# APPEAL #2

**PRELIMINARY SUBDIVISION STAFF ANALYSIS REPORT**  
*(As of June 3, 2025)*

CASE NO.: 2022-2903-PP

SUBDIVISION NAME: Maison du Village

# Grading and Drainage Plan - Inset A

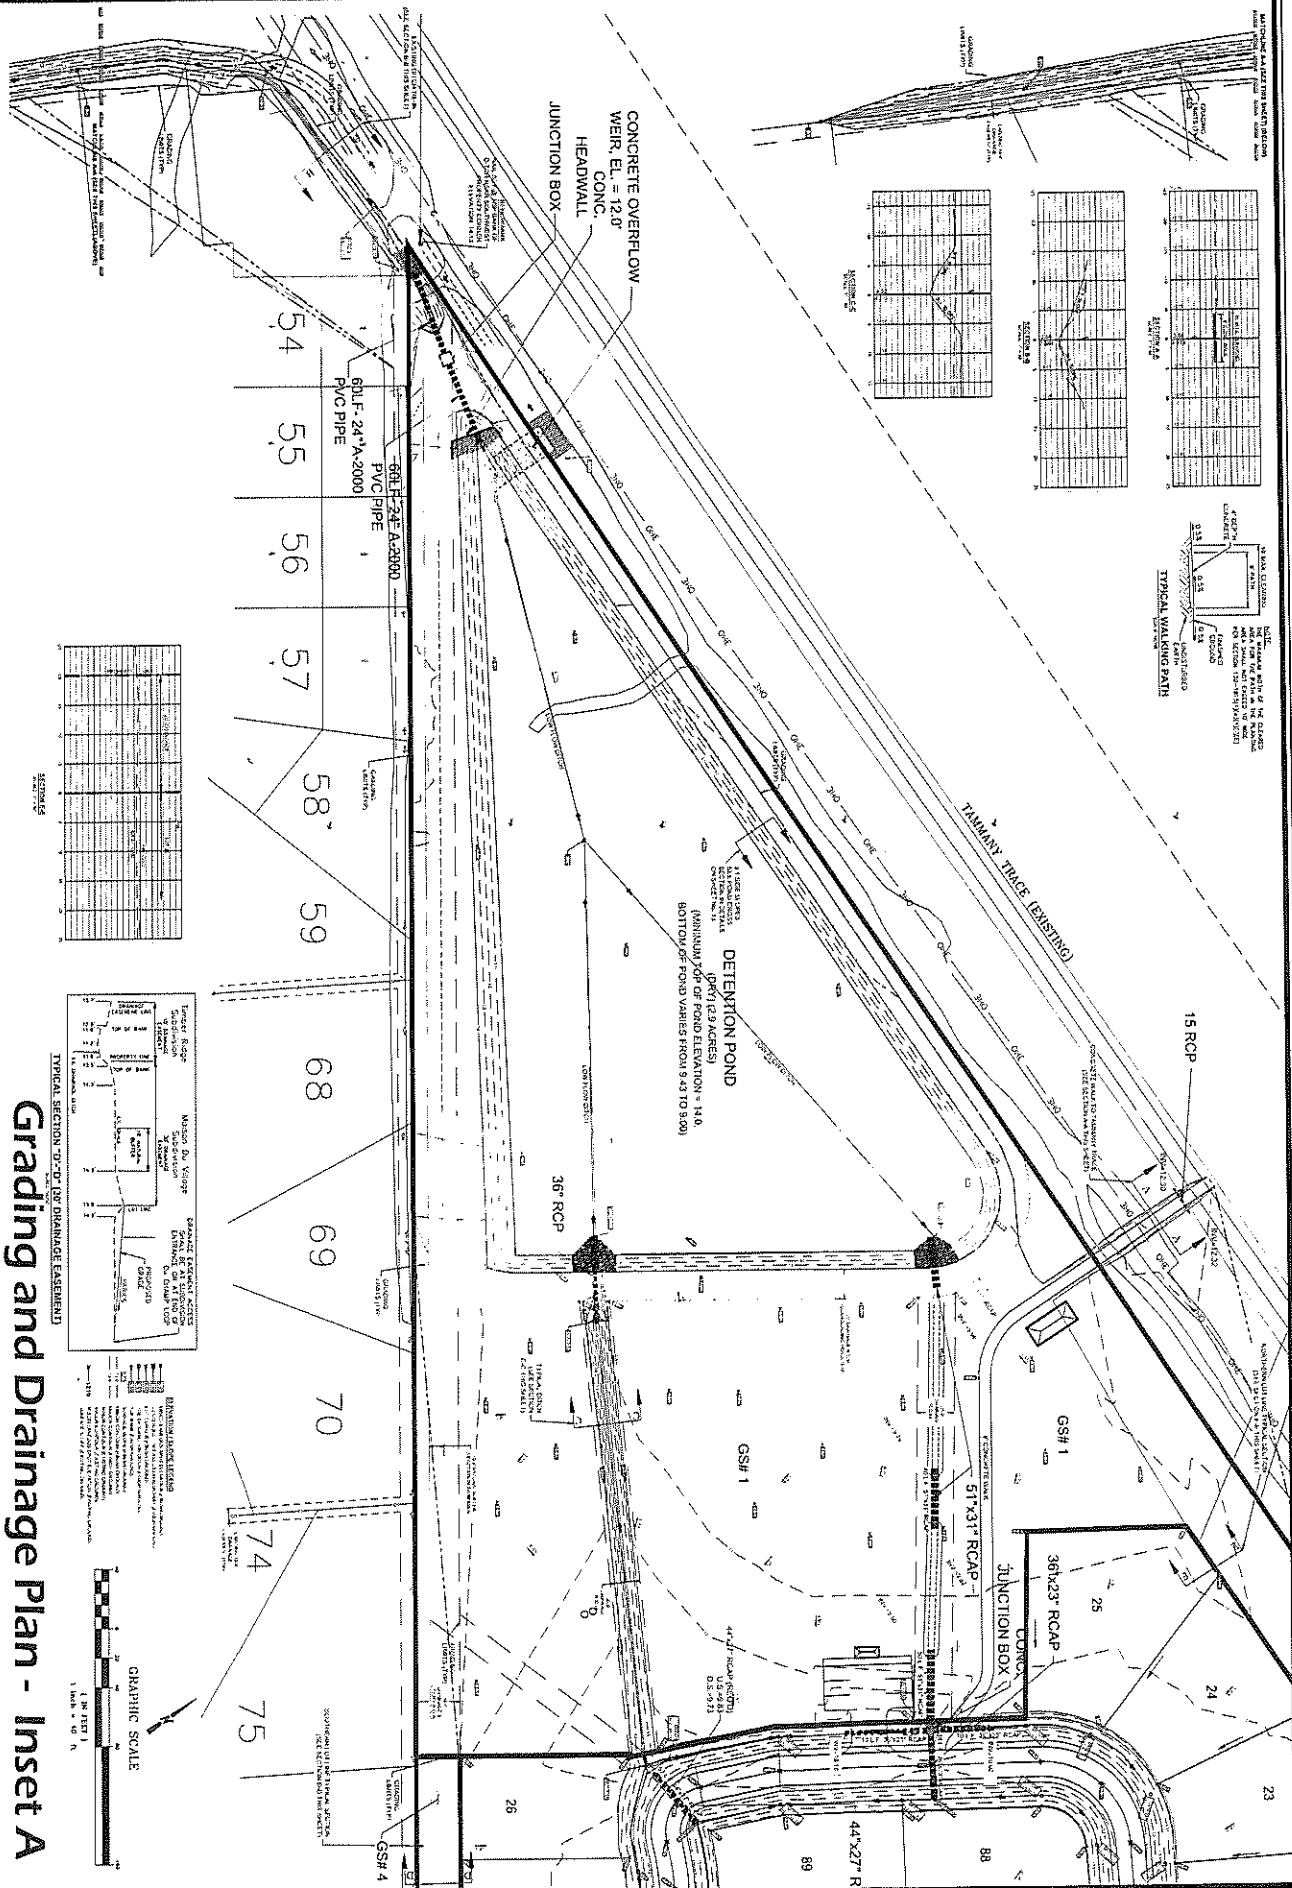
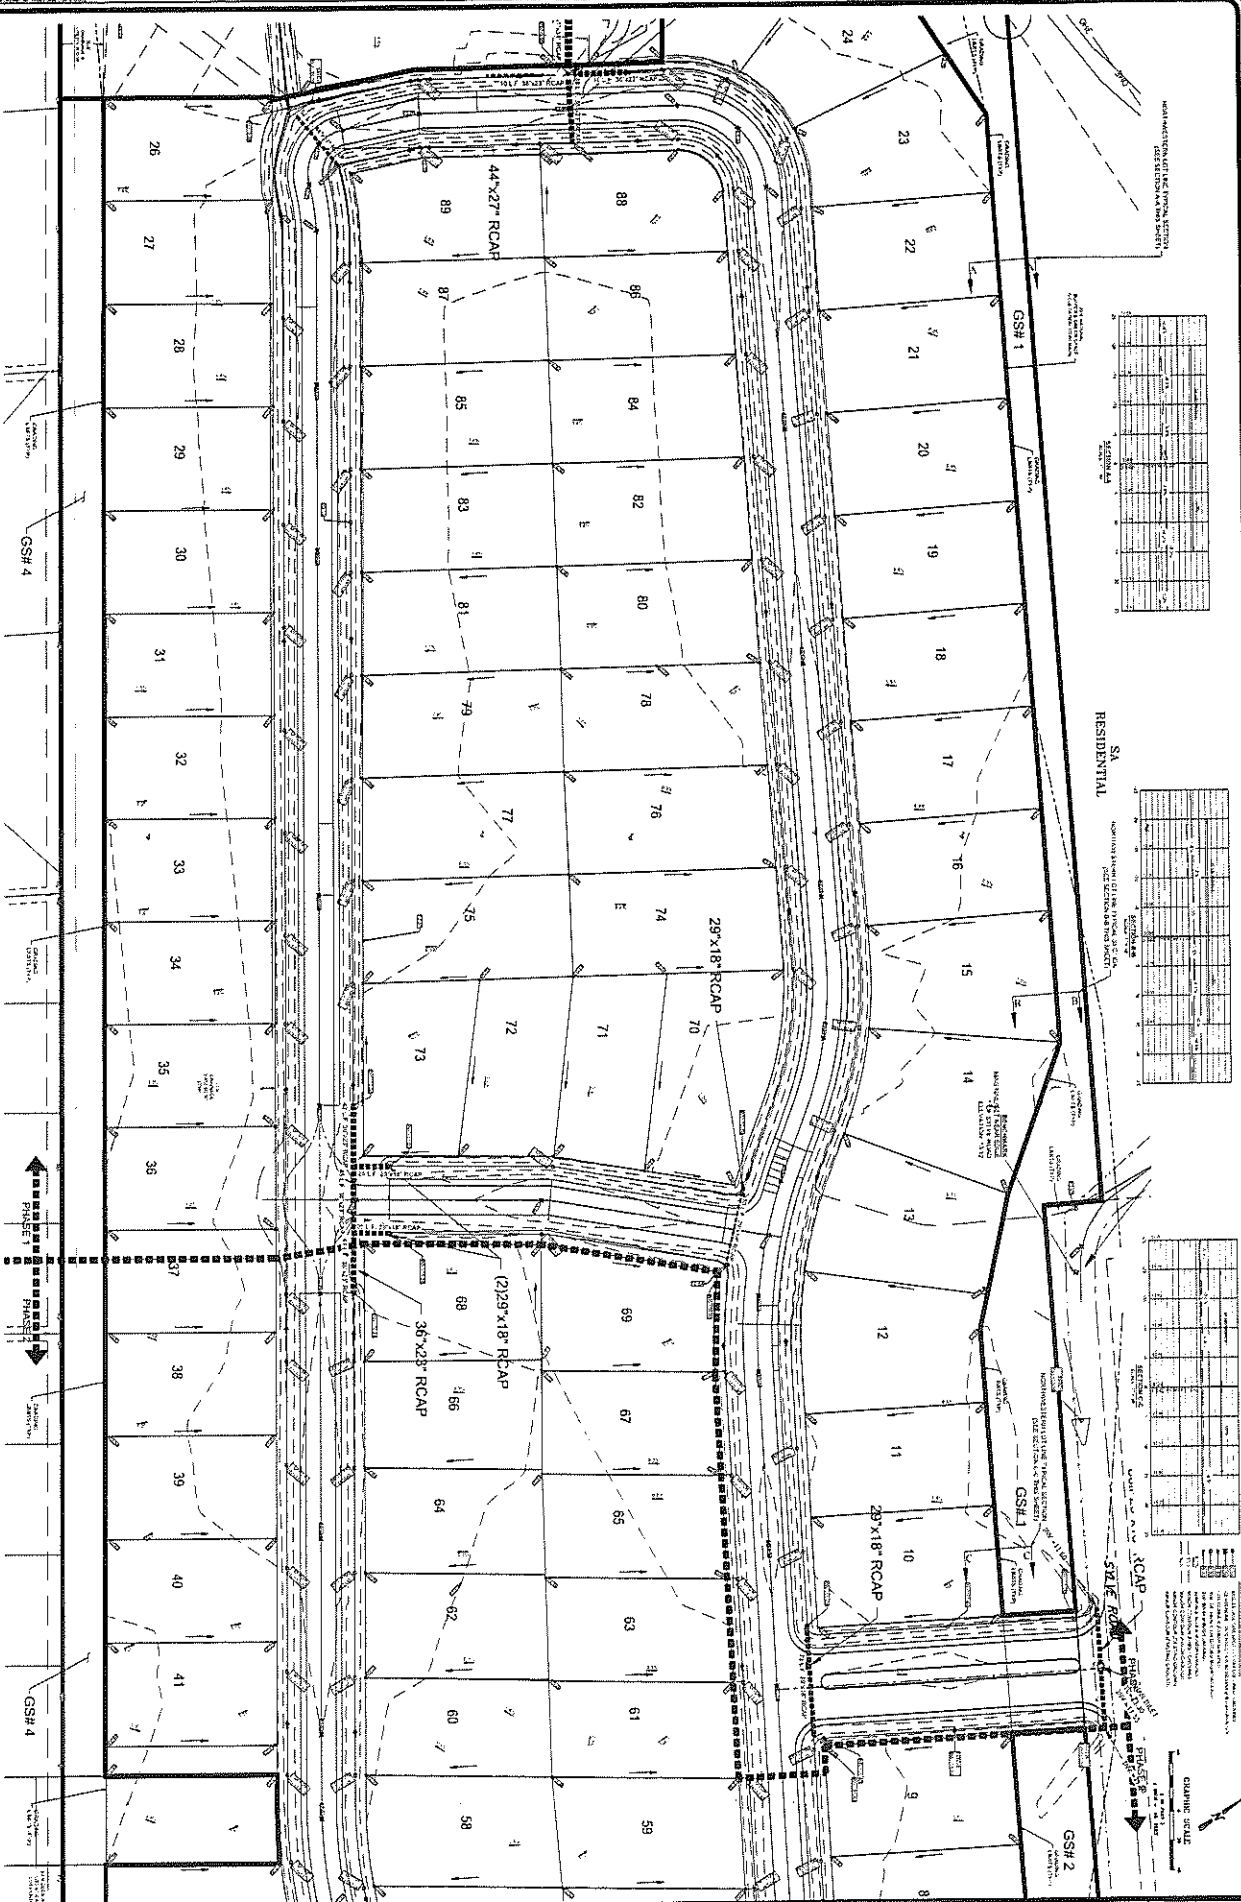
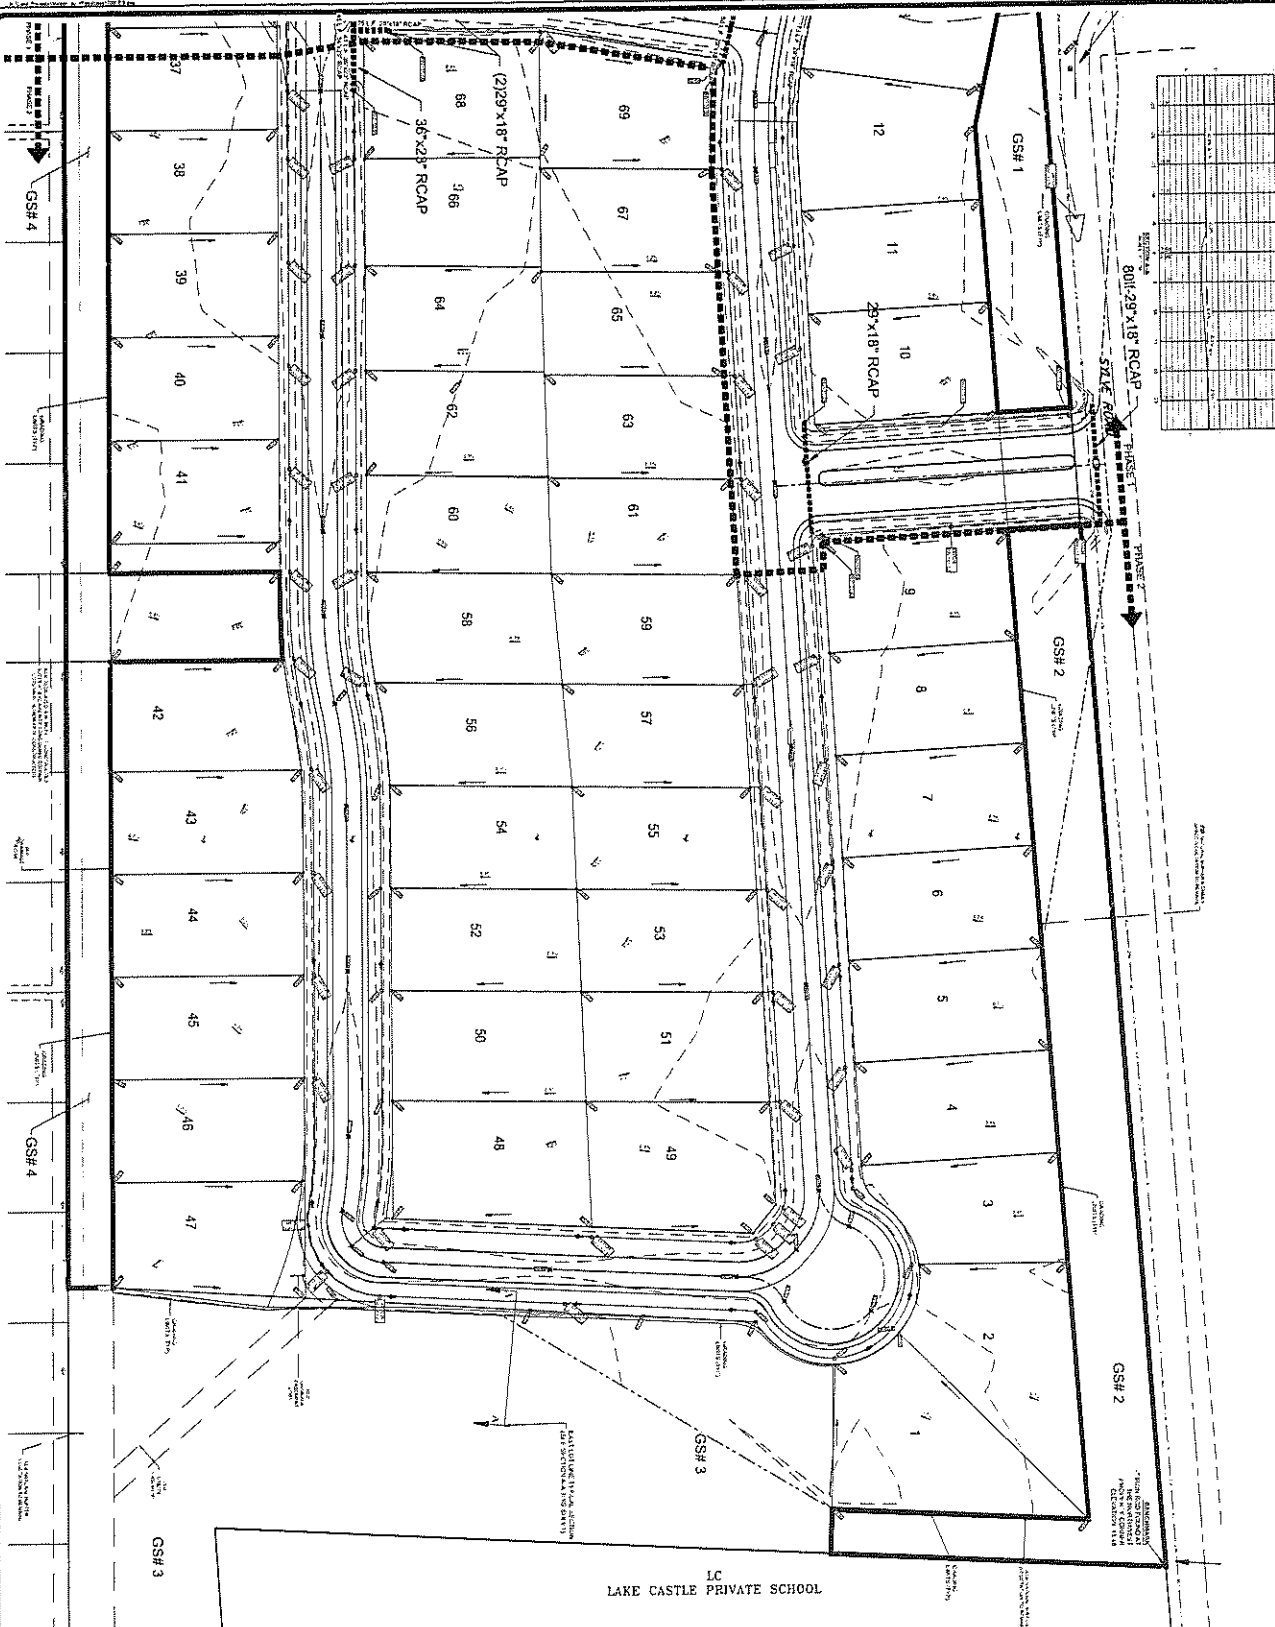
6. The Drainage & Grading Plans and the Drainage Impact Study need to be updated to reflect and account for the previous comments and markup summaries issued to the developer and the engineer of record on June 3, 2025.
